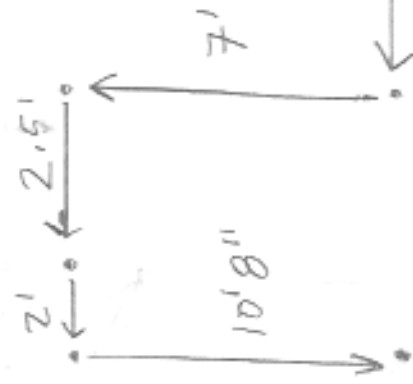
* total travel distance
from farthest seat
to 1st floor

46' 3"

over concessions

* provide clearance
 □ = framing - existing structural posts and making
 window openings - specifying the amount
 framing as necessary
